STATE OF MAINE
DEPARTMENT OF TRANSPORTATION
16 STATE HOUSE STATION
AUGUSTA, MAINE 04333-0016

October 18, 2021
Subject: Interstate 295/US Route 1
Northbound & Southbound Bridge
Replacements & Multiuse Path
State WINs: 023106.01 & 023825.00
Location: **Yarmouth**
Amendment No. 2

1-295 OVER US ROUTE 1
EXIT 17 INTERCHANGE
CUMBERLAND
YARMOUTH
BEARING LAYOUT - NB

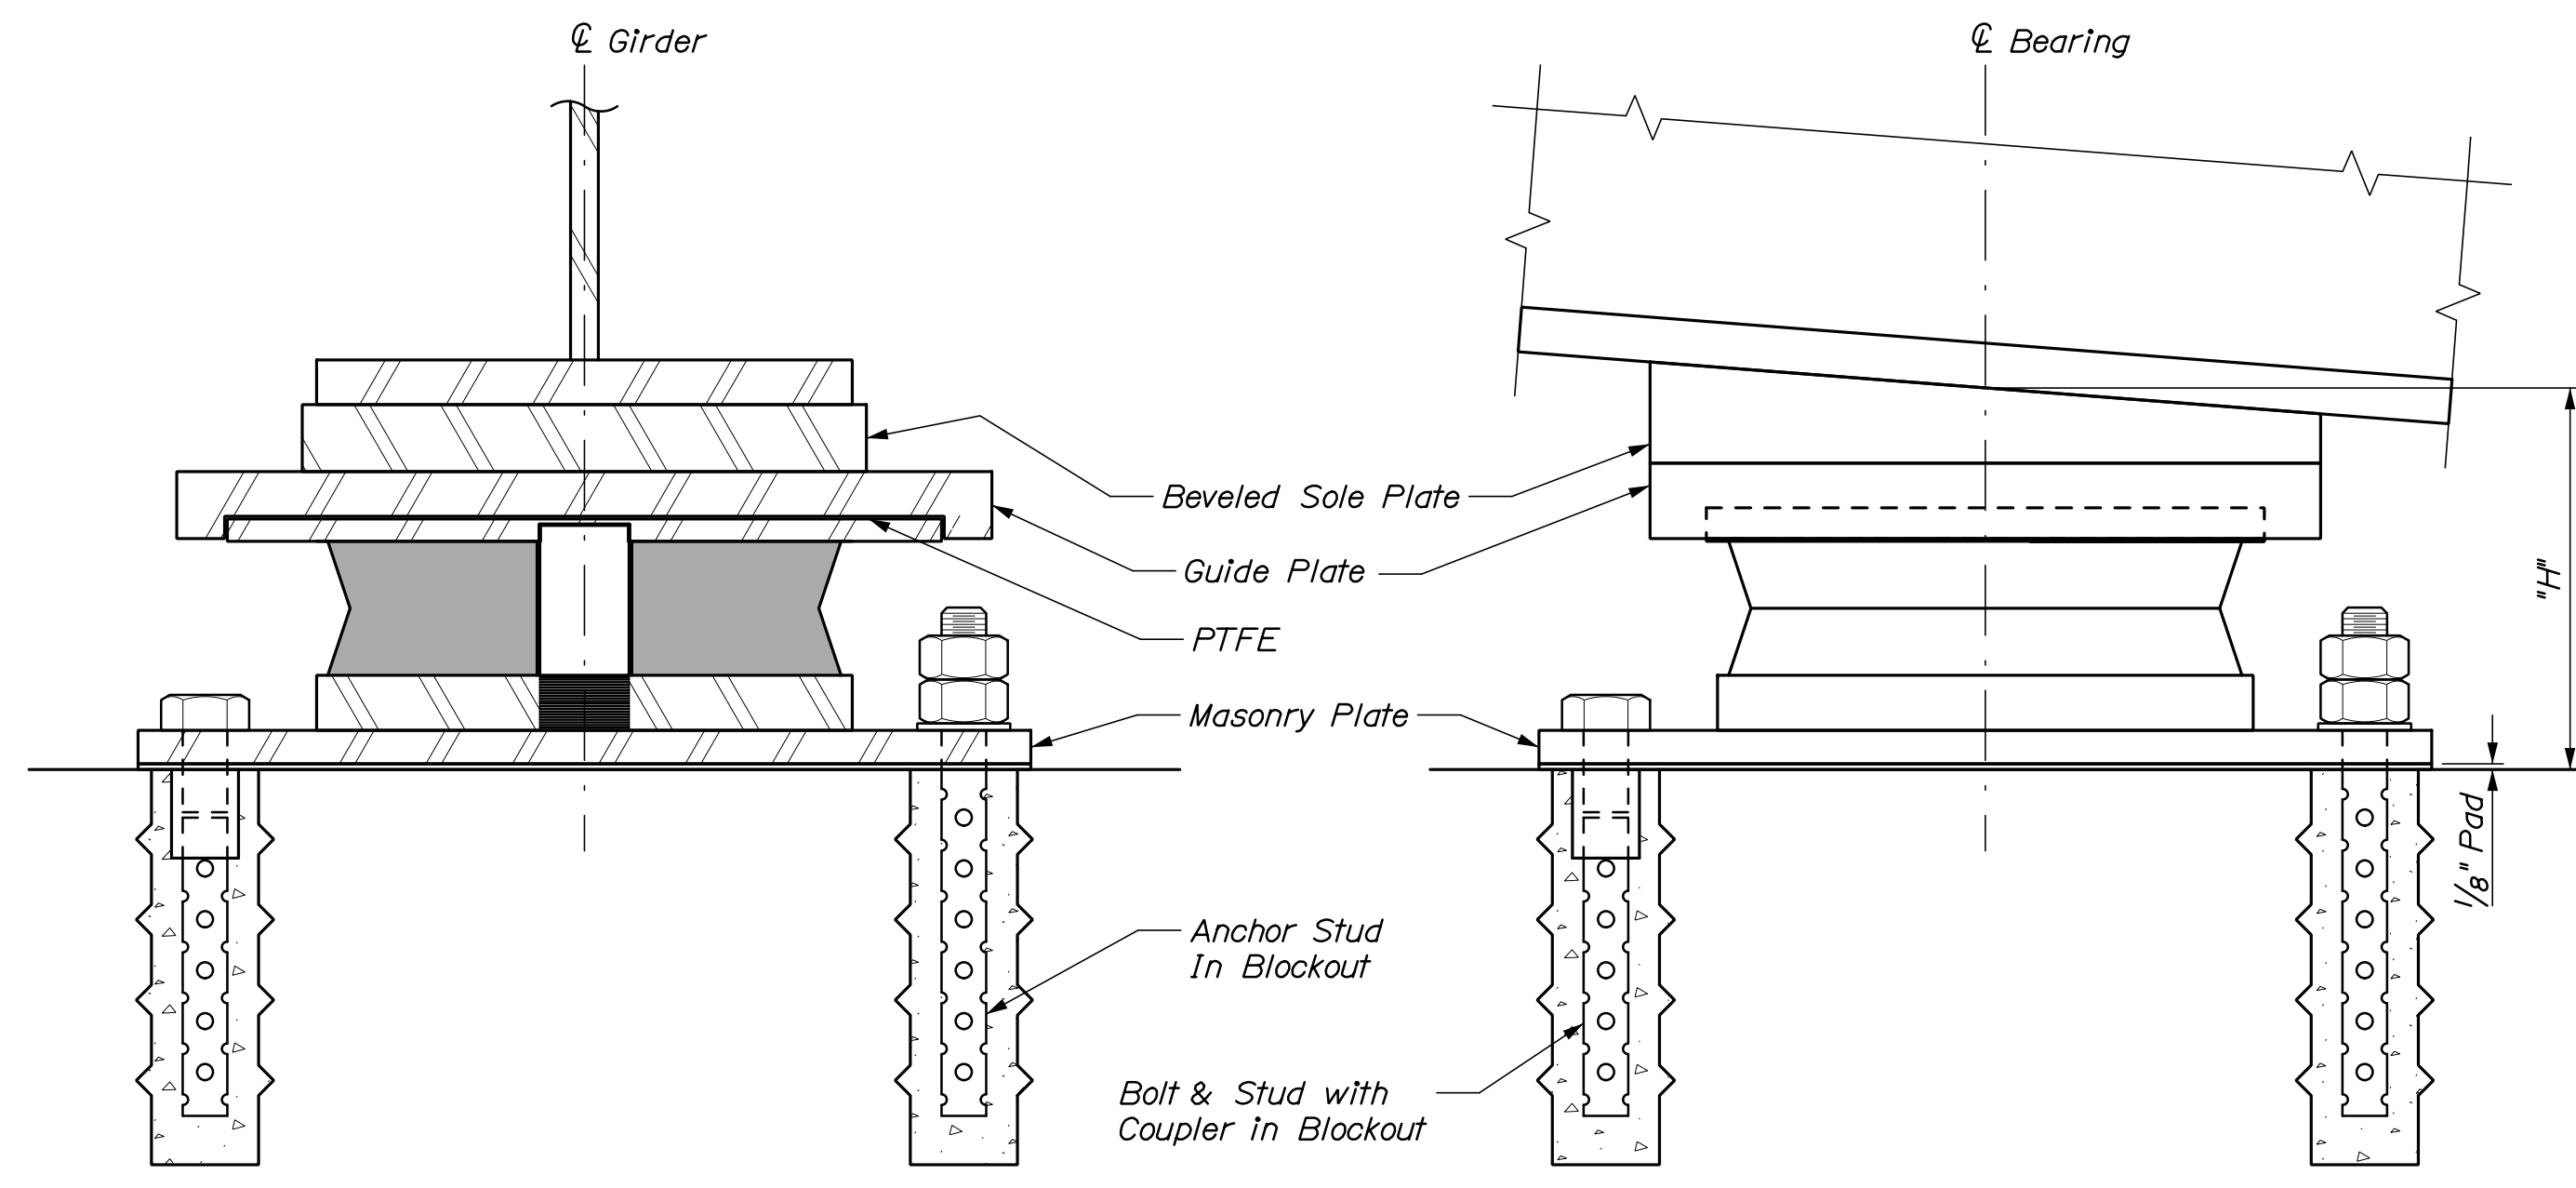
Question: The Disc Bearings for Bridge 1509 – Abutment No. 1 and Bridge 5833 – Abutment No. 2 have Service Horizontal Loads (HL) GREATER THAN the Service Vertical Loads (VL) - as much as 185% HL vs. VL. This is contrary to AASHTO recommendation and requirements for HLMR bearings. No such loading combinations has ever been attempted to our knowledge and it is doubtful that a disc bearing will work properly or withstand this type of loading conditions without some kind of damage. No type of testing of loading conditions such as these is even possible since the bearing would be forced out of the test press due to the much higher horizontal load.

Question: The NB and SB bridges have significantly different design rotations. Can you please confirm the design rotations stated for the Bridges?

Response: Please see changes to the plan set.

Response: Please see changes to the plan set.

BEARING DETAILS - NB

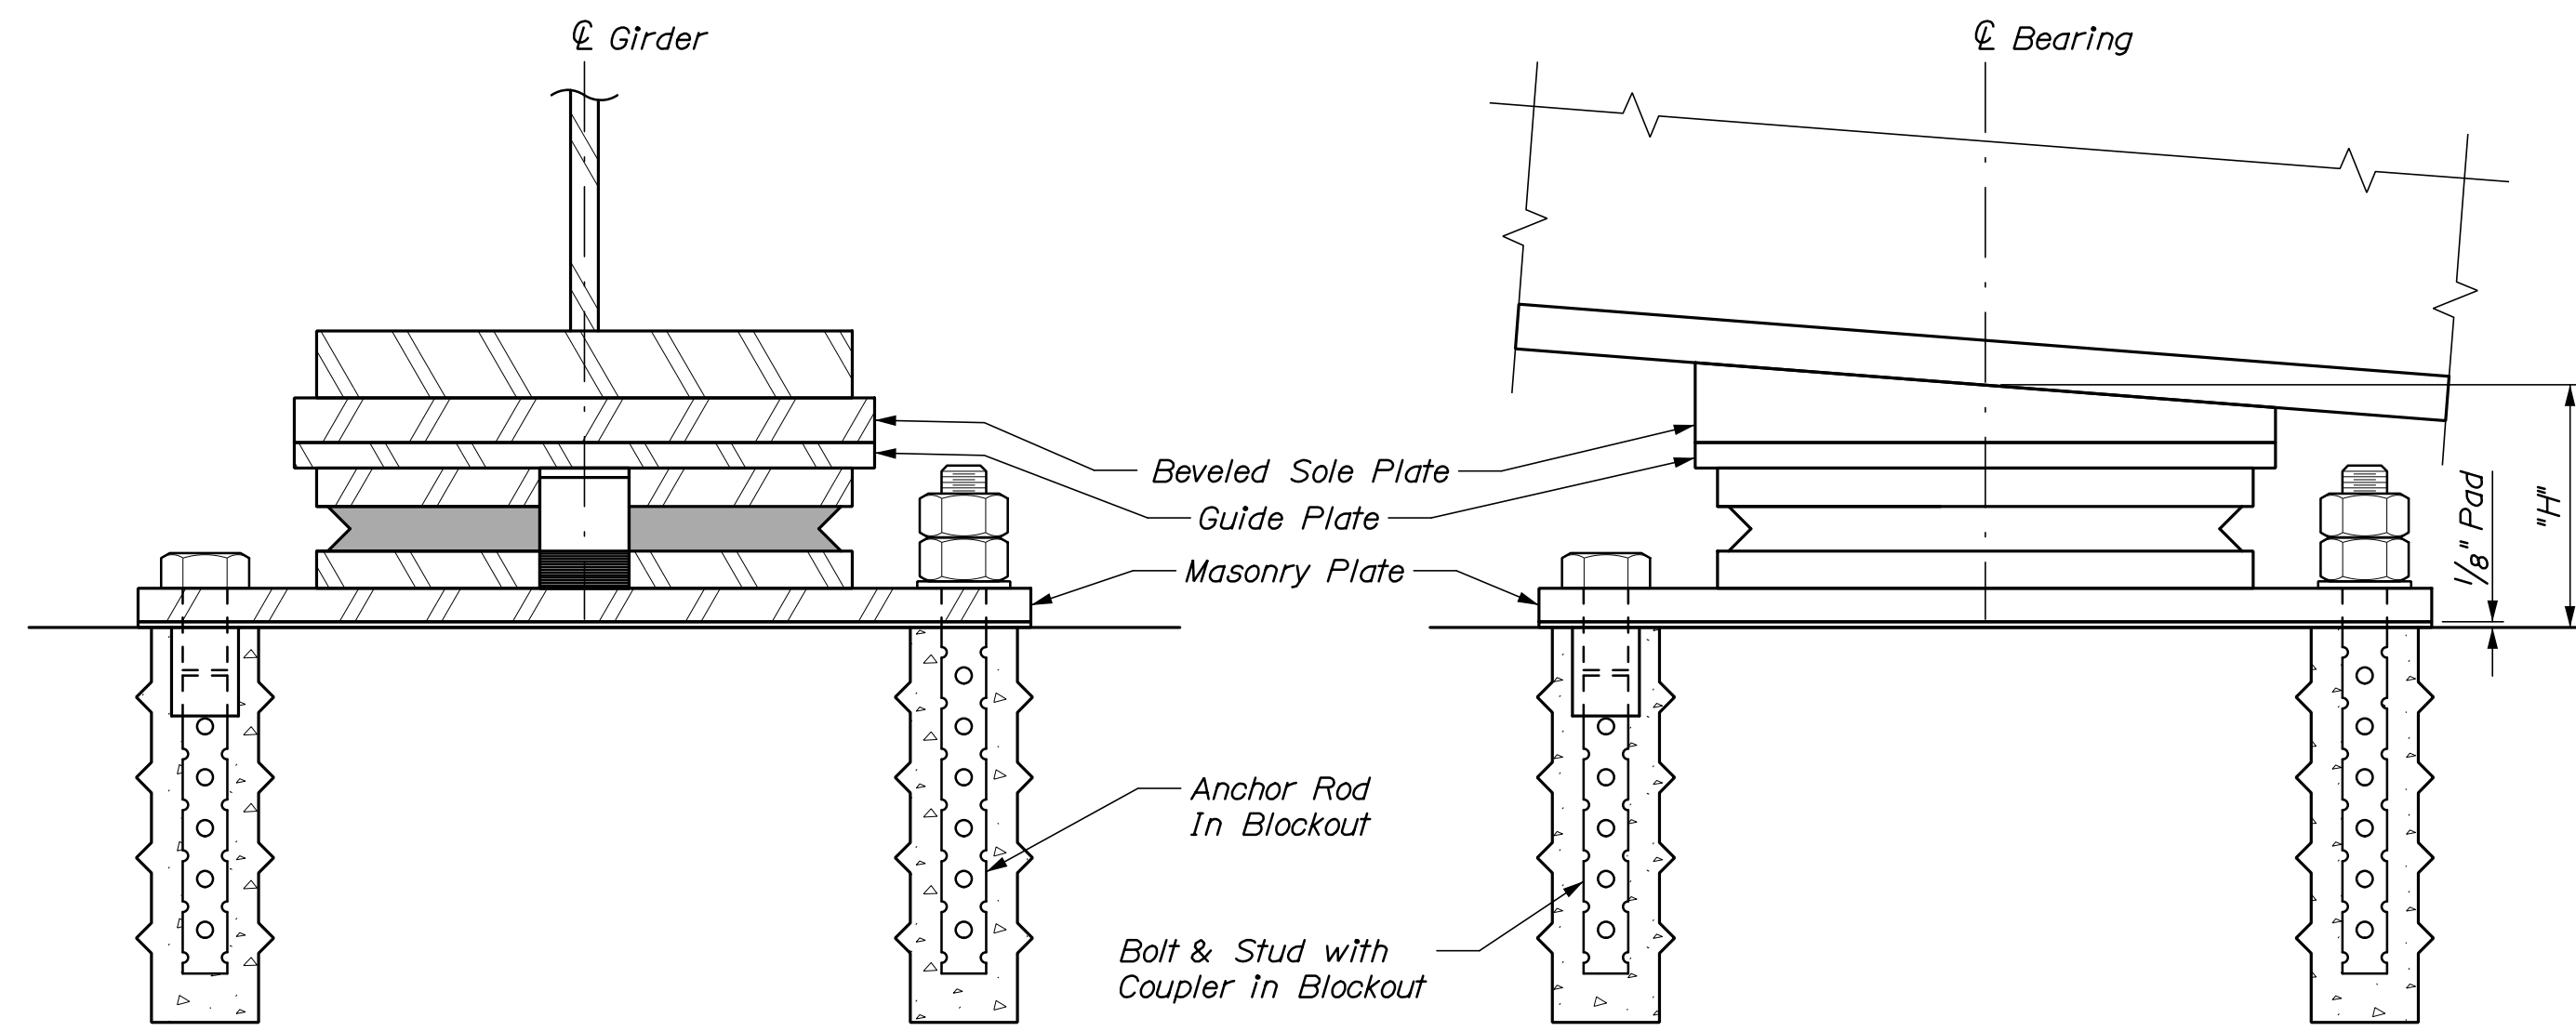
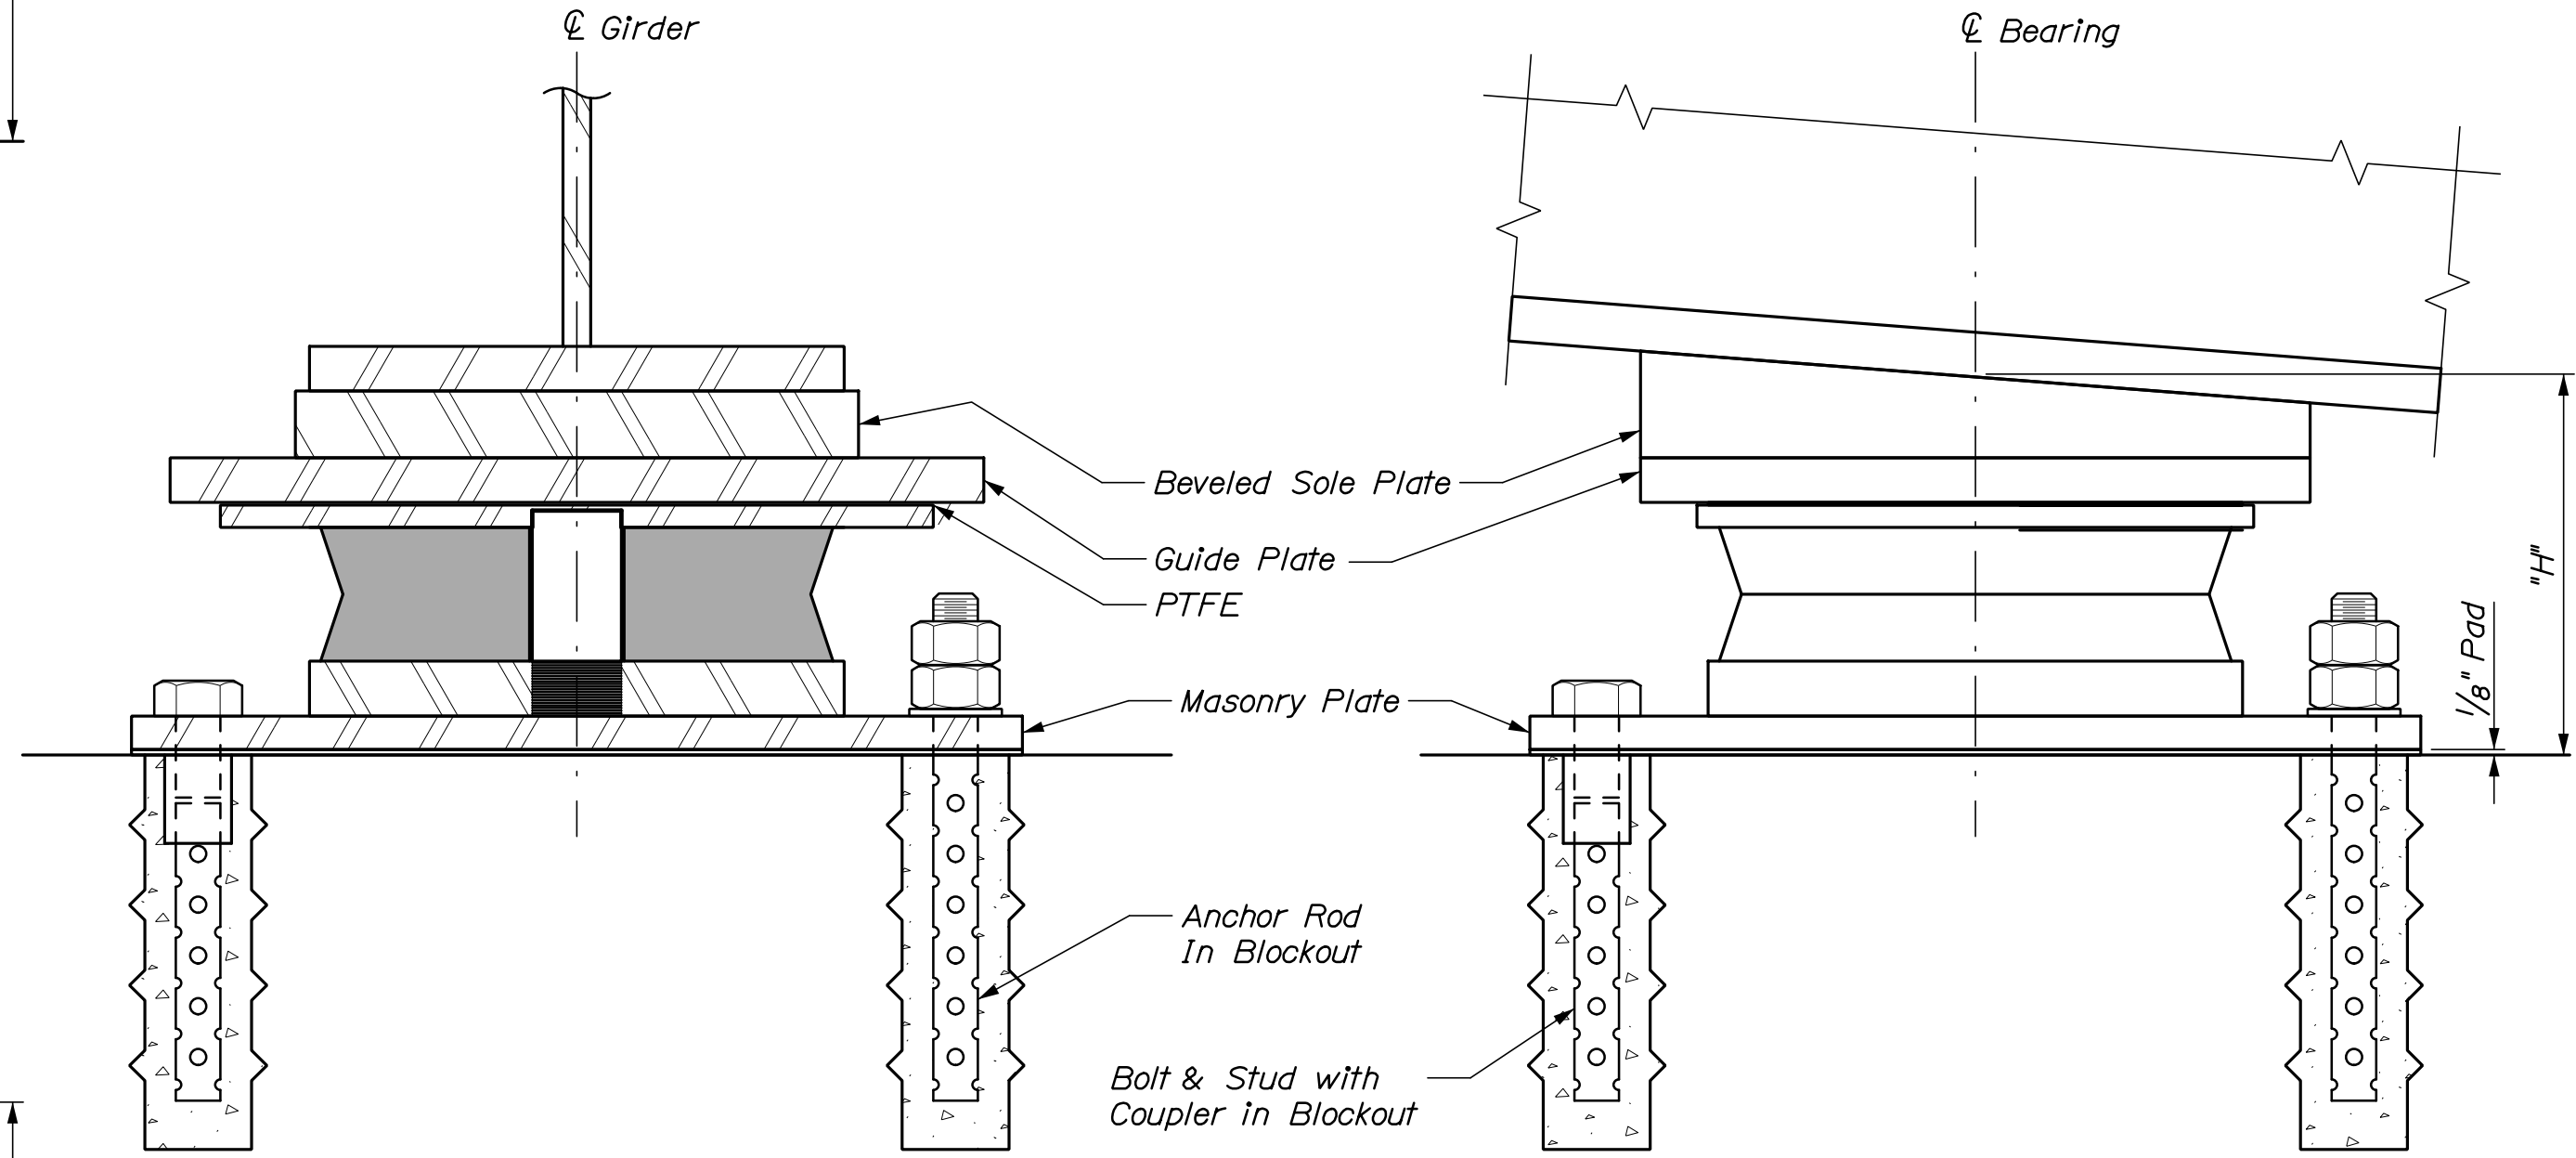
Question: Please see sheet number 277 of 312, “Bearing Details – NB”. Bridge No. 5833. Please confirm that the design rotation values are correct in the Disc Bearing Design Table. Design rotations over 0.02 are unusual, some of the rotation values shown are double that.

Question: Please see Disc Bearing Design Tables located on sheets 238 of 312, and 277 of 312. The horizontal loads shown for the fixed and transverse expansion bearings are greater than their vertical loads. Horizontal loads this great are not ordinary. Please confirm that the horizontal loads shown in the Disc Bearing Design Tables are correct.

Response: Please see changes to the plan set.

Response: Please see changes to the plan set.
